Part Number: A071X161					 3D image provided when available for visual reference only.	
	Change Notice	CN00069931	Alternates				
	Manufacturer Part (MEP)	No	Usage	Production Only			
	Release Phase Code	Production (P)	Drawing Specification	Number: DS47102987			
	External Regulations	No External Regulation		Revision: D

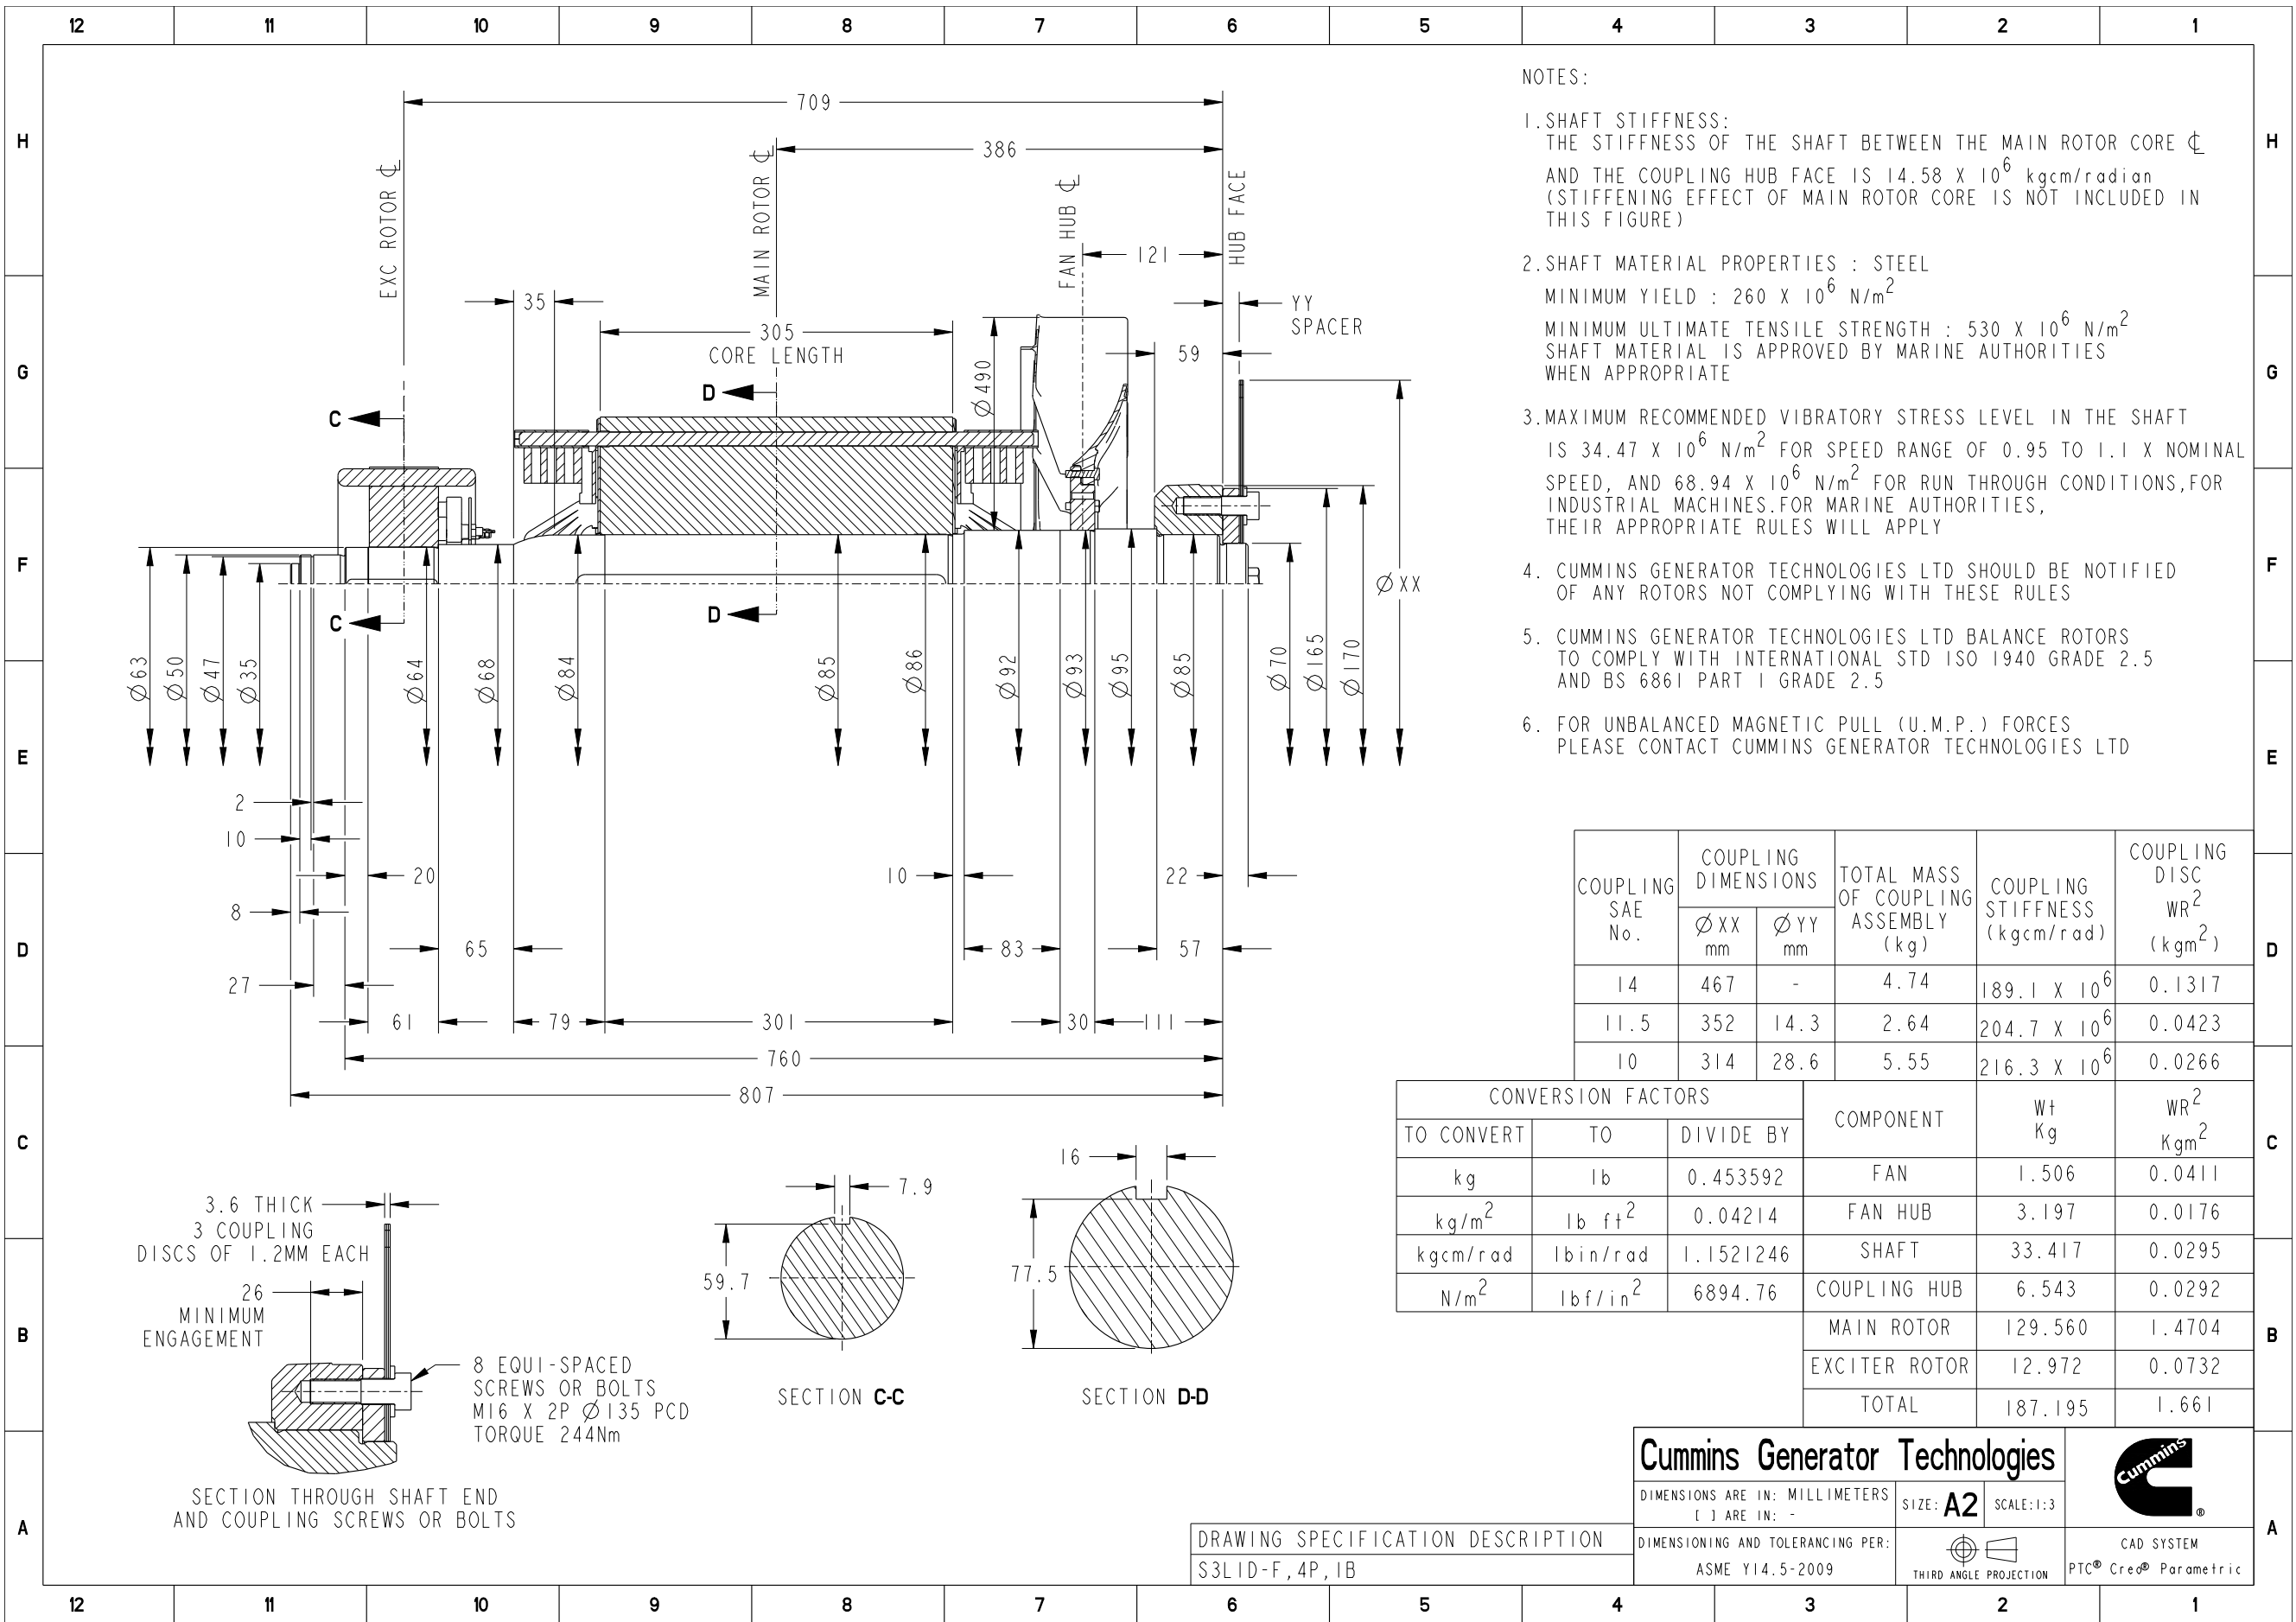
Drawing Revision Information							
Description of Change(s) Note: Change information is provided for reference only and does not supersede the drawing's primary content. 1.ZONE C/2,1 IN TABULATION FAN HUB TOTAL WT. 3.197 WAS 1.490 2.ZONE B,C/2,1 IN TABULATION SHAFT TOTAL WT. 33.417 WAS 33.504 3.ZONE C1, IN TABULATION FAN HUB INERTIA 0.0176 WAS 0.0087 4.ZONE B/C,1 IN TABULATION SHAFT INERTIA 0.0295 WAS 0.0277 5.ZONE D/7, DIM 83 WAS 78 & DIM 30 WAS 35 6.ZONE H/6,7, DIM 121 WAS 128 7.ZONE E,F/8 DIM 86 WAS 91 8.ZONE H/1,2,3,4 SHAFT STIFFNESS 14.69 WAS 14.58 9.UPDATE VIEW PICTORIALY ADMINISTRATIVE CHANGE(S) TO PART ATTRIBUTES, BILL OF MATERIAL, OR ASSOCIATED SPECIFICATIONS.
